February 10, 2006

**Re: Floodplain GE-Pittsfield/Housatonic River Site  
Floodplain Residential and Non-Residential Properties Adjacent to 1½ Mile Reach of  
Housatonic River (GEC710 and GEC720)  
Addendum to Removal Design/Removal Action Work Plan for the Phase 4 Floodplain Properties**

### **Revised Technical Drawing No. 7: Excavation Limits for Group 4A**

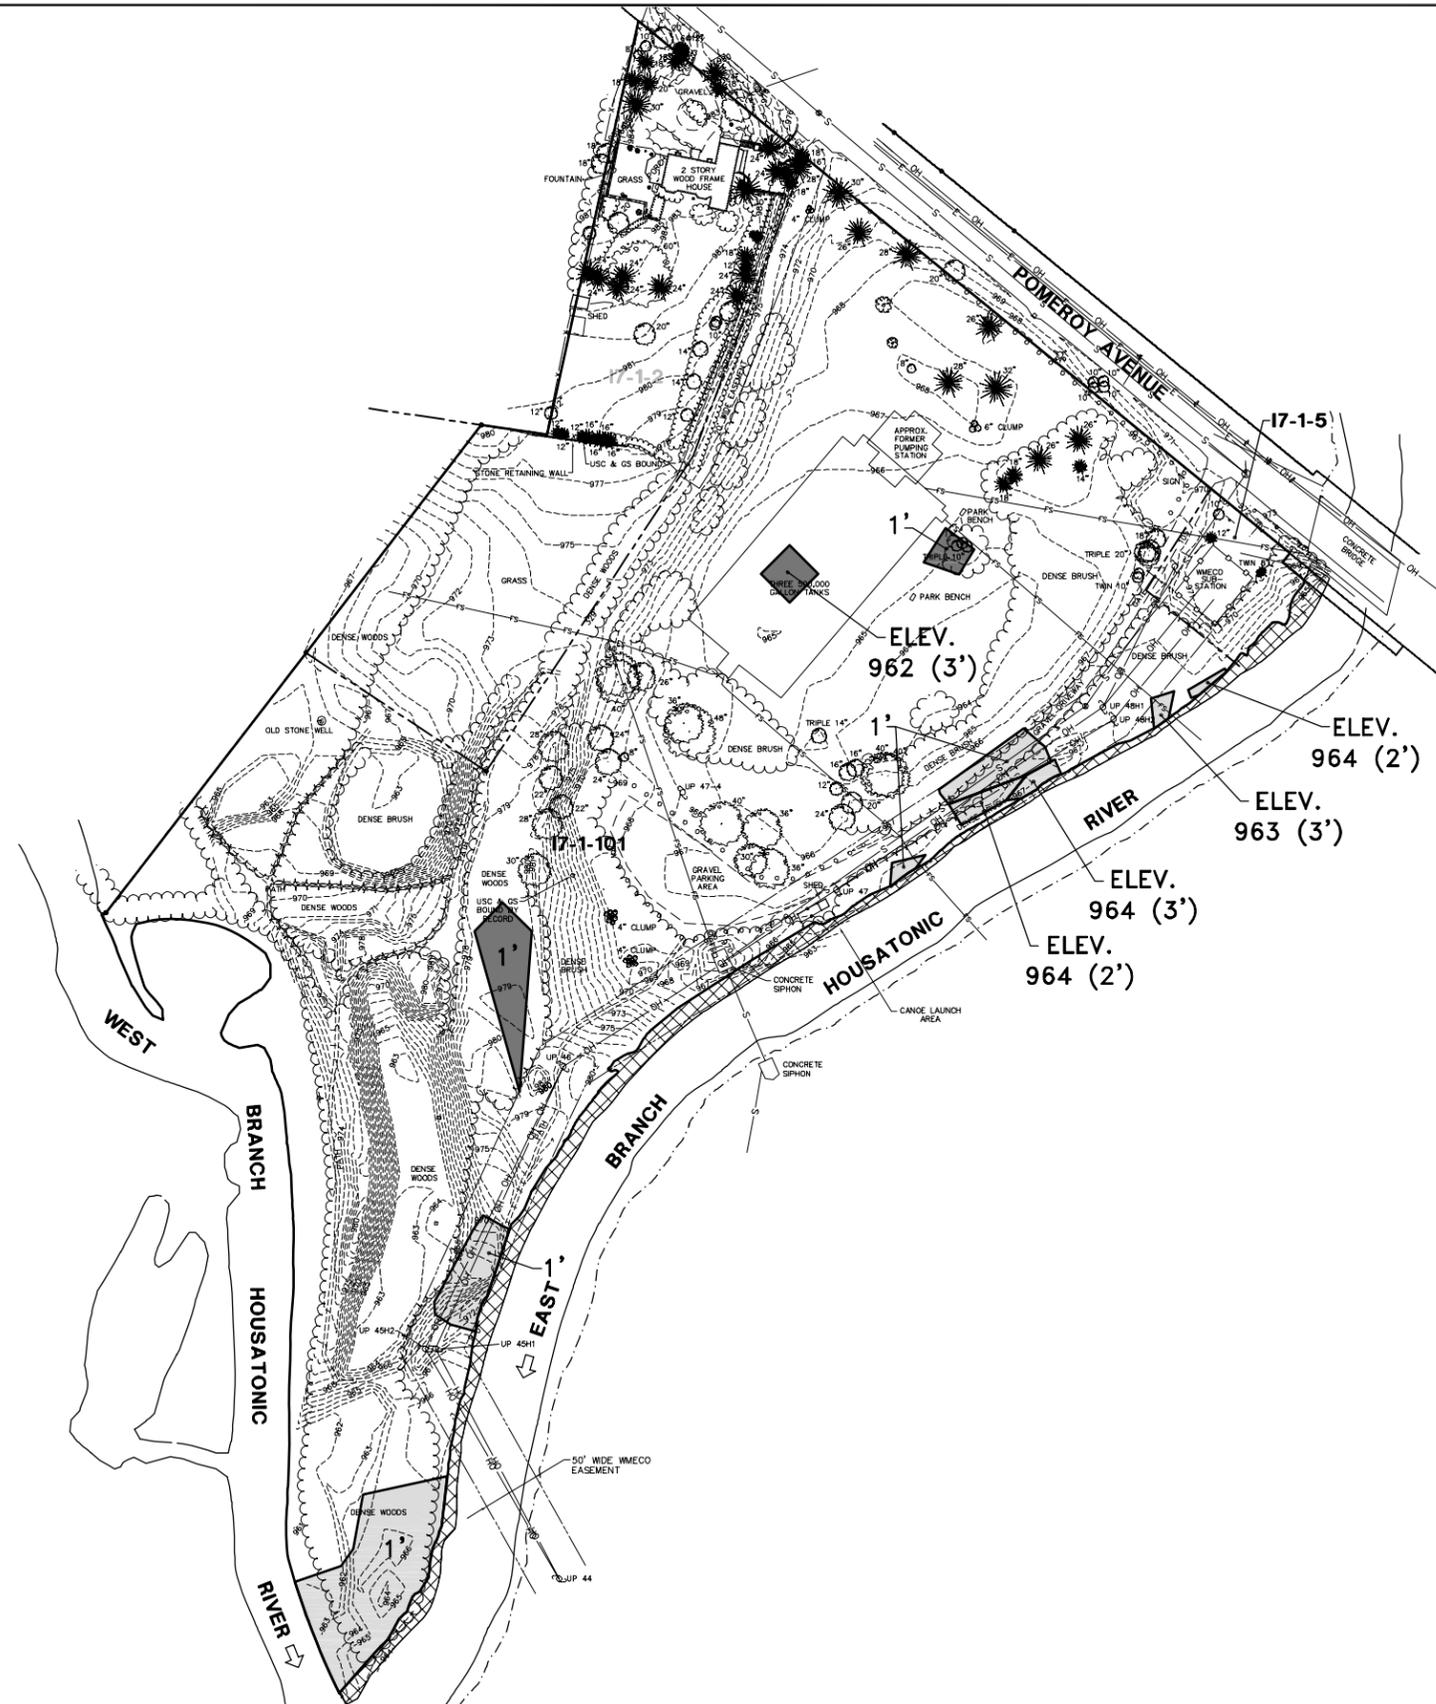
EPA Comment No. 1 – *Based on constructability and other factors, GE shall consider expanding the excavation limits shown on Technical Drawing 7 of the Work Plan to a 2-foot depth in the vicinity of boring locations RB021921 and RB021882, and to a 3-foot depth in the vicinity of boring locations BW-0017 and RB021922.*

GE Response – GE has elected to expand the excavation limits to a 2-foot depth in the vicinity of boring locations RB021921 and RB021882, and to a 3-foot depth in the vicinity of boring locations BW-0017 and RB021922, based on constructability and related factors. The revised excavation limits are shown on revised Technical Drawing 7, attached to this letter as Attachment A.

**Figure 1 from May 1999  
Site Investigation Report for the  
General Electric Residential Sampling  
Project, Residential Property – R89,  
presenting location of  
EPA sample RA89EE000**

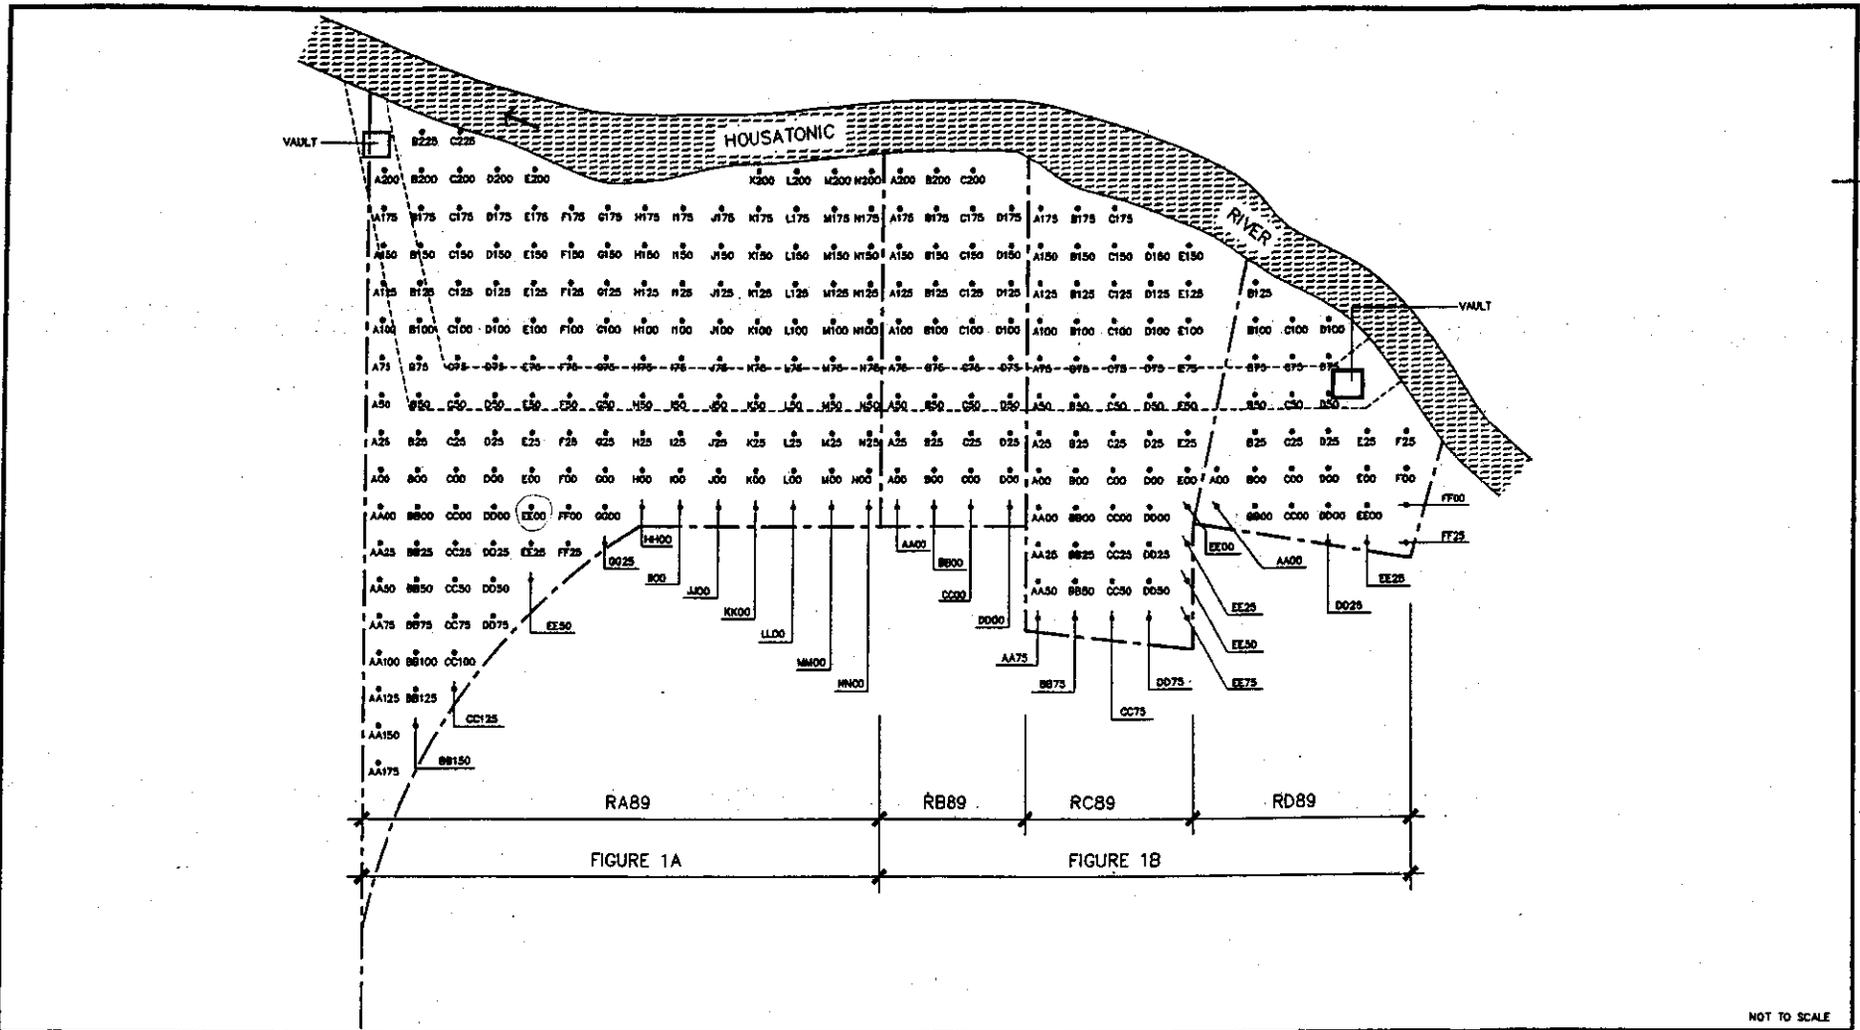
EPA Comment No. 3 – *The location of soil sample number RA89EE000 shown on Figure 1-5 does not agree with EPA's plot of the data. GE shall review the location of this soil sampling location and revise the excavation limits as shown on Technical Drawing 9, if necessary.*

GE Response – In Comment No. 1 of EPA's June 14, 2005 conditional approval letter for GE's *Pre-Design Investigation Report for Phase 4 Floodplain Properties* (copy provided in Attachment C), EPA stated that "GE shall compare the EPA sampling locations shown on the figures in the Report to those shown in the above-referenced documents and modify them accordingly in the RD/RA Work Plan for the Phase 4 Floodplain Properties." The "above-referenced documents" referred to documents titled *Site Investigation Report for the General Electric Residential Sampling Project, Residential Property – R72* and *Site Investigation Report for the General Electric Residential Sampling Project, Residential Property – R89*. A copy of Figure 1 from the latter document indicating the location of soil sample number RA89EE000 is provided in Attachment D. In response to that directive, GE revised the location of soil sample number RA89EE000 from a location based on the survey coordinates previously provided by EPA to a location generally consistent with the location of that sample shown on the figure provided in Attachment D. That revised location was presented on Figure 1-5 of the RD/RA Work Plan. Thus, the location shown on that figure is generally consistent with the location shown on Attachment D.

### **Revised Figure 9-1: Proposed Primary and Secondary Travel Routes for Excavated Materials to OPCAs**

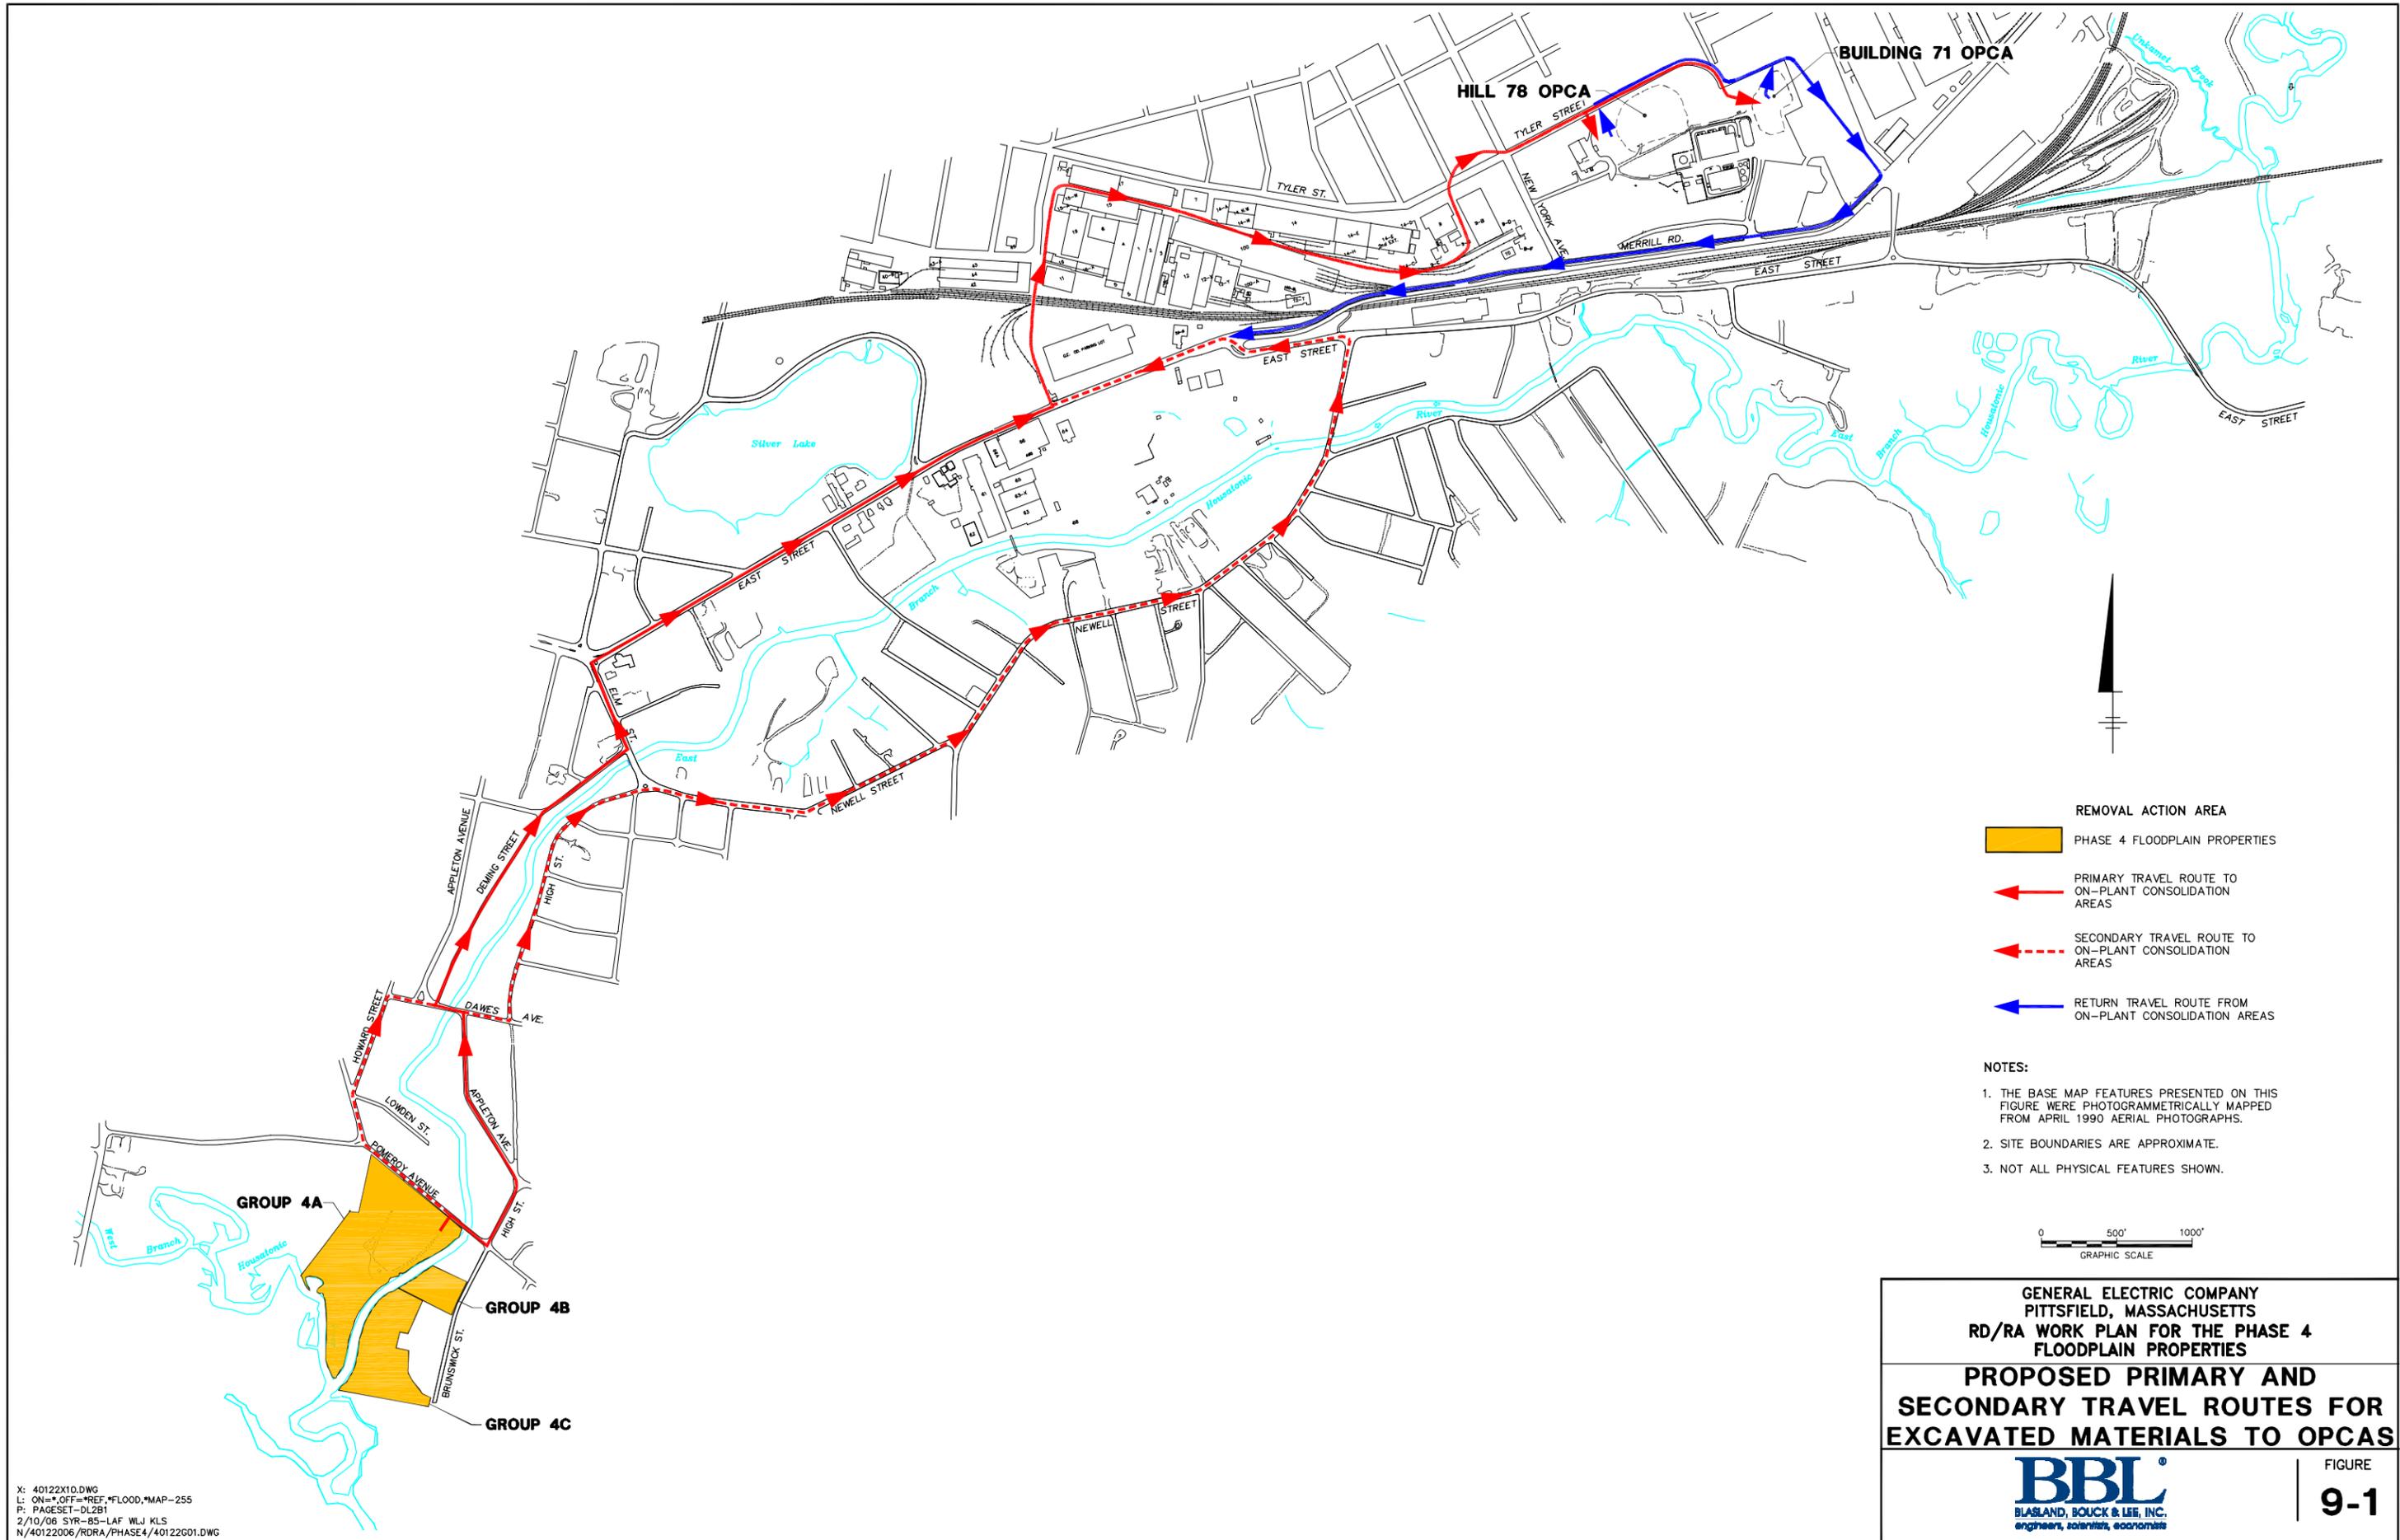
EPA Comment No. 4 – *GE shall revise the truck traffic routes shown on Figure 9-1 based on recent modifications to the operating procedures for the On-Plant Consolidation Areas (OPCAs).*

GE Response – GE has revised the truck traffic routes presented on Figure 9-1 to be in accordance with the operating procedures for the On-Plant Consolidation Areas (OPCAs). Figure 9-1 has been revised and attached to this letter as Attachment E.
